Summerlin V23B Sky Vista Dr. Alta to Fox Hills
Update #2

CITY OF LAS VEGAS		DATE:
INTER-OFFICE MEMORANDUM		May 9, 2019
TO: Land Development Services Department of Building & Safety		FROM: Albert Sung, P.E. Flood Control Project Engineer Department of Public Works
SUBJECT: Drainage Study for: Summerlin V23B Sky Vista Dr - Alta to Far Hills – Update #2		COPIES TO: GCW, Inc.
Cross Streets:	Sky Vista Drive from Alta to Far Hills	The Howard Hughes Company, LLC
File Number:	F:\Depot\DSMemos\DS4980F.doc	Bart Anderson, P.E., DevCo
Parcel Number:	137-22-000-017	CCRFCD
Zoning Action:	MDR-72841	
FEMA Flood Zone	YES NO X	
Proposed Storm Drain	YES X NO

**UPDATE #2 TO THE
TECHNICAL DRAINAGE STUDY FOR
VILLAGE 23B SKY VISTA DRIVE
ALTA DRIVE TO FAR HILLS AVENUE**

**Re: Update #2 to the Technical Drainage Study for
Summerlin Village 23B Sky Vista Drive – Alta Drive to Far Hills Avenue (DS4980)**

DRAWING 14
14 OF 46 SHTS

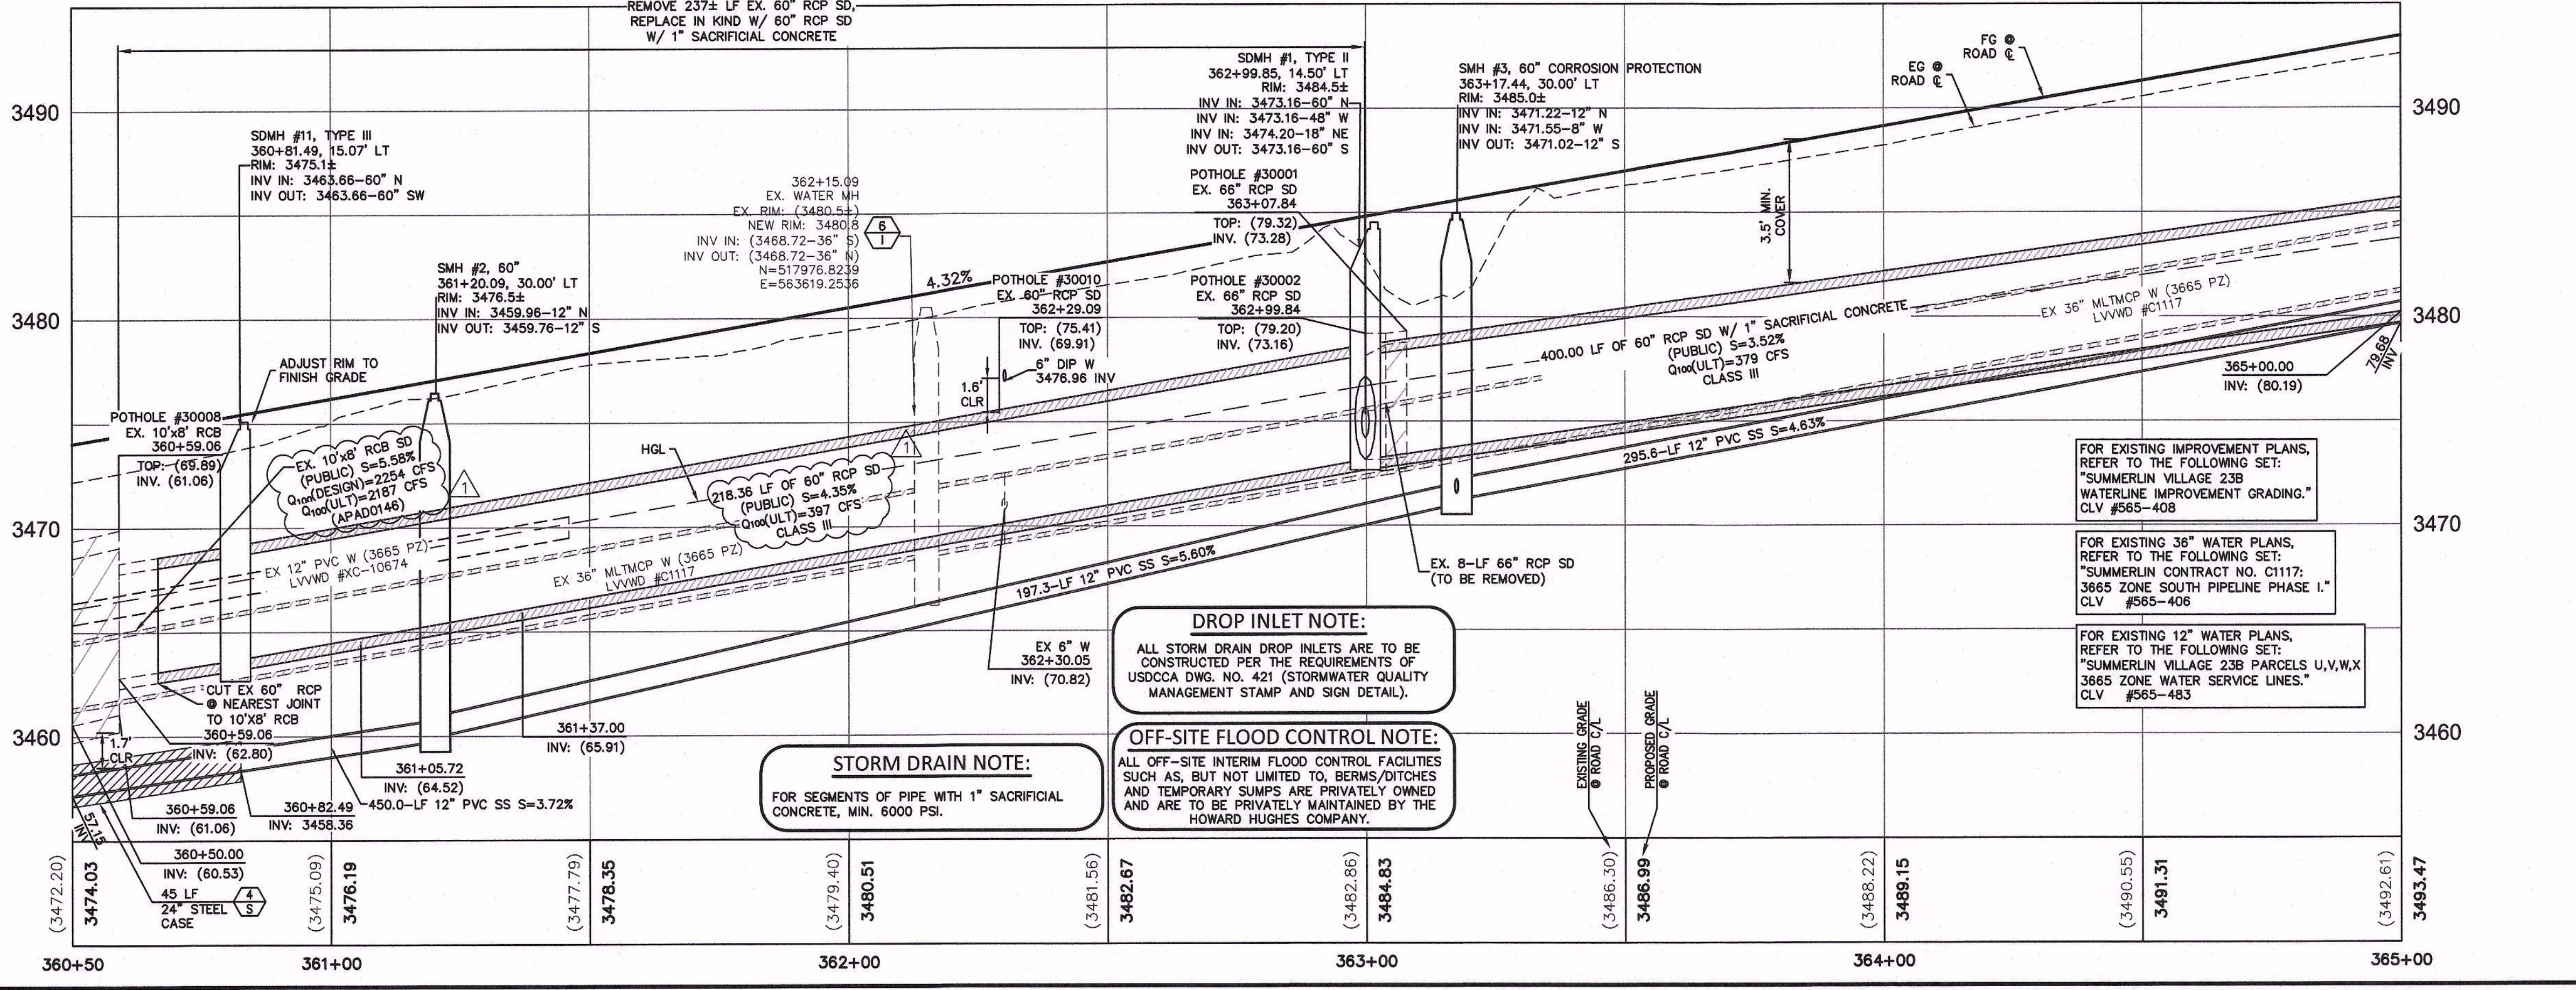
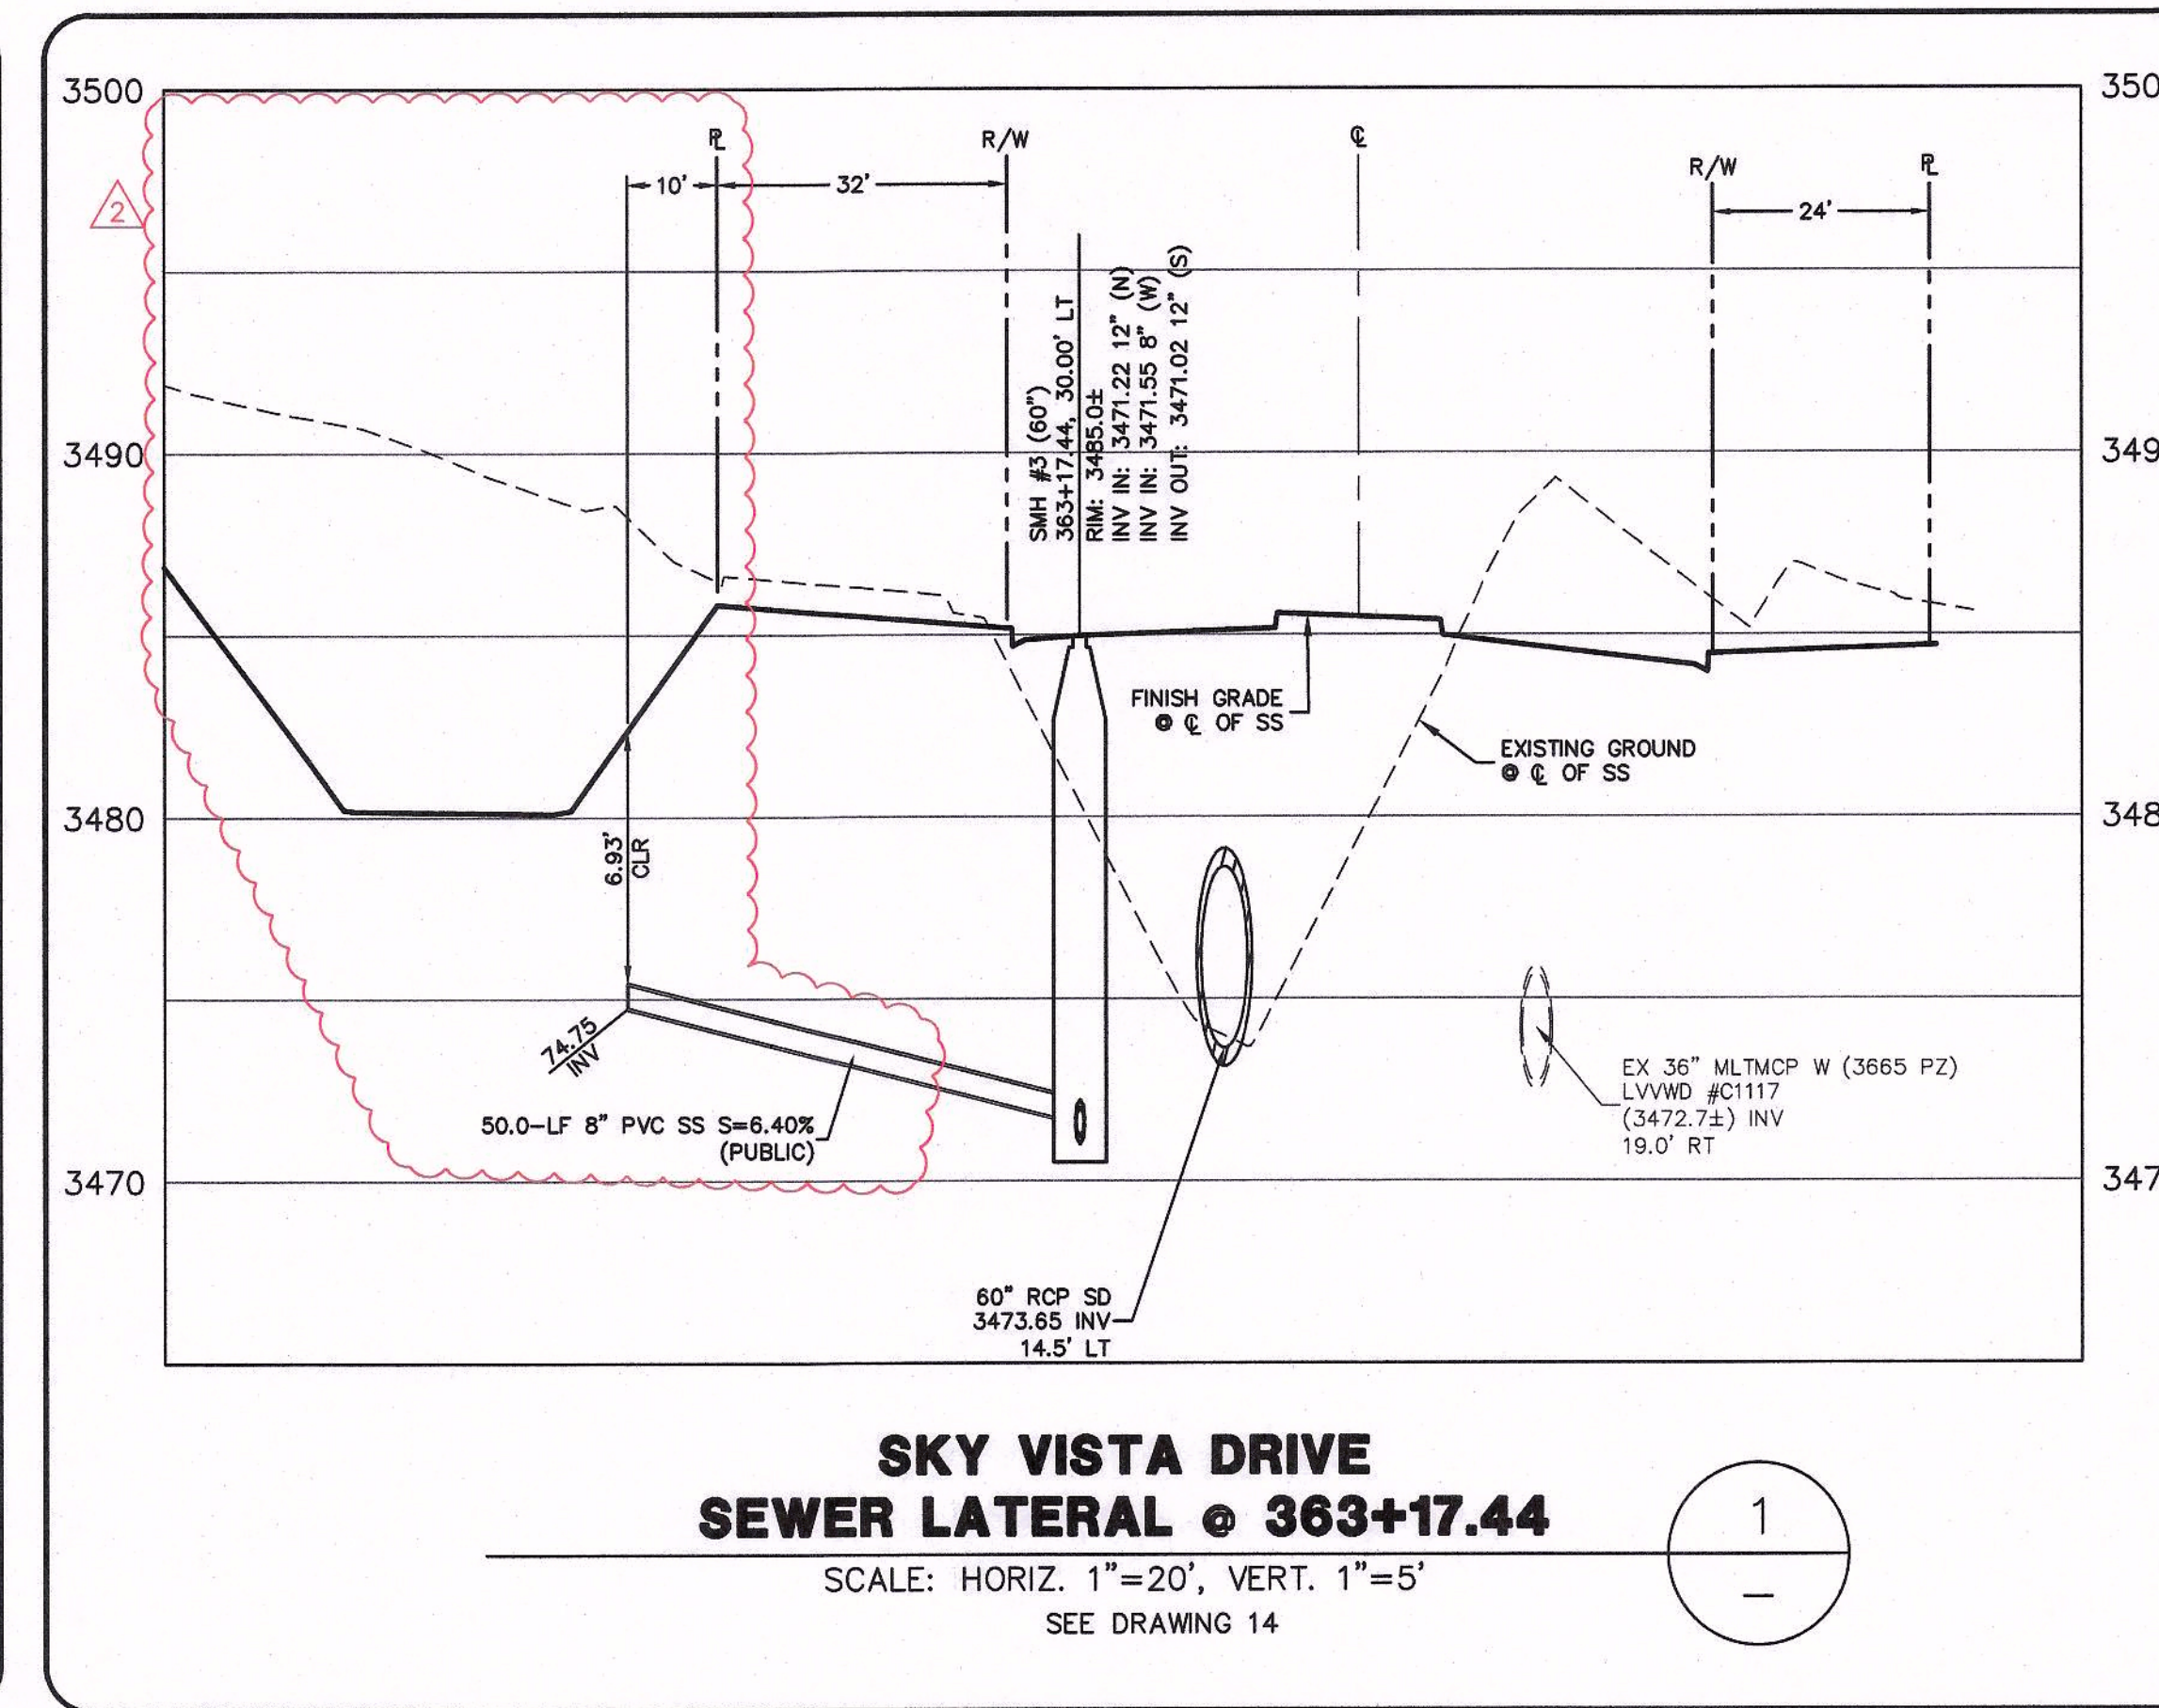
3. Revise all added nuisance drop inlets (DIs #7, #8, #9, #12, #13 and #14) to Type CM. Note that the lengths of CM inlets are in the multiple of 2.5'. Revise the length call out from 4' to 5'.
4. The segment of existing 60"-storm drain to be replaced with additional sacrificial concrete as shown on *Sheet 14* must be provided with a structural detail on the plans. A Special Construction Note must be added to the Grading Plans and the Plan and Profile Sheet that calls out the special construction requirement for the additional sacrificial concrete.
5. All offsite interim flood control facilities such as but not limited to berms / ditches and temporary sumps are privately owned and to be privately maintained by the *Howard Hughes Company*.
